**AGENDA  
PLANNING AND ZONING COMMISSION  
FEBRUARY 18, 2020**

**TO:** Planning and Zoning Commission  
**FROM:** Jonathan Beckham, Planner  
**DATE:** February 18, 2020  
**SUBJECT:** **Regular Hearing: Final Plat of First Park 121 Addition, Lot 6, Block A; on 33.924 Acres out of the Samuel M. Hayden Survey, Abstract Number 537; Zoned Light Industrial District (LI); Located on the South Side of Midway Road, Approximately 209 Feet East of Holfords Prairie Road, Being a Replat of Coyote Theater Addition, Lot 1, Block A.**

SHEET 1 OF 3  
FINAL PLAT  
**FIRST PARK 121 ADDITION**  
**LOT 6, BLOCK A**  
33.924 ACRES (ZONED LI)  
BEING A REPLAT OF  
COYOTE THEATER ADDITION  
LOT 1, BLOCK A  
DOCUMENT NO. 2016-32  
AND BEING OUT OF THE  
SAMUEL M. HAYDEN SURVEY, ABSTRACT NO. 537  
CITY OF LEWISVILLE, DENTON COUNTY, TEXAS

**TO:** Planning and Zoning Commission  
**FROM:** June Sin, Planner  
**DATE:** February 18, 2020  
**SUBJECT:** **Regular Hearing: Final Plat of Wyndale Meadows Addition, Phase 1, Lots 2R1 & 3, Block N; on 3.056 Acres out of the B.B.B. & C.R.R. Survey, Abstract Number 180; Zoned General Business District (GB); Located on the Northwest Corner of Windhaven Parkway and

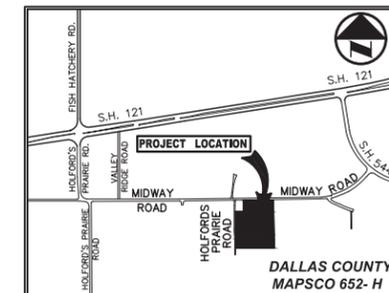
Show the centerline and width per section 6-73(c)

Please contact the engineering department for additional easements that might be required for the Holdfords Prairie Roadway project.

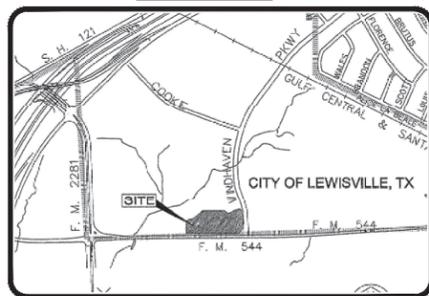
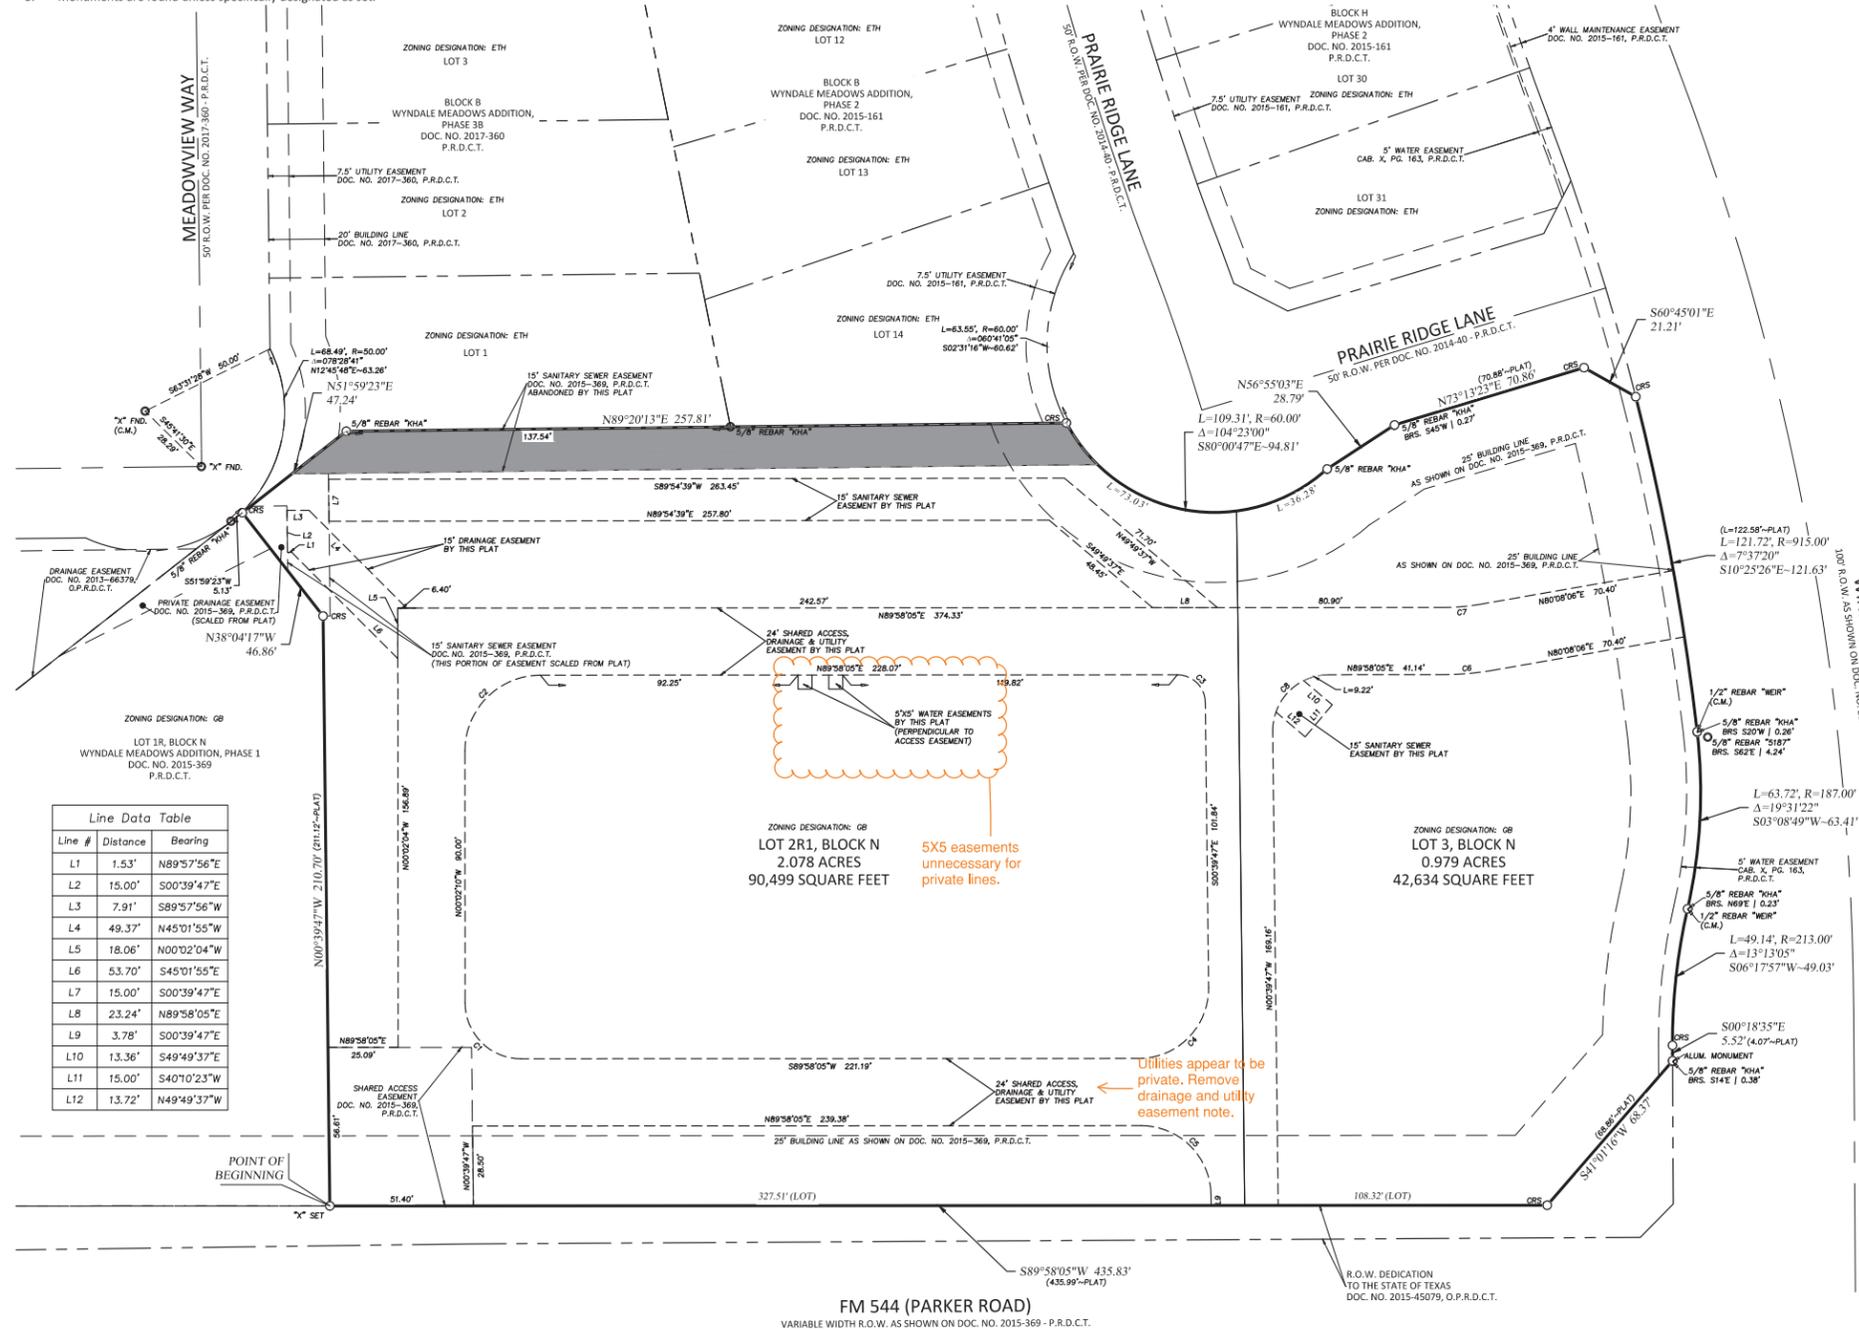
## Utilities appear to be private. Remove drainage and utility easement note. (1)

Utilities appear to be private. Remove drainage and utility easement note.

Utilities appear to be private. Remove drainage and utility easement note.
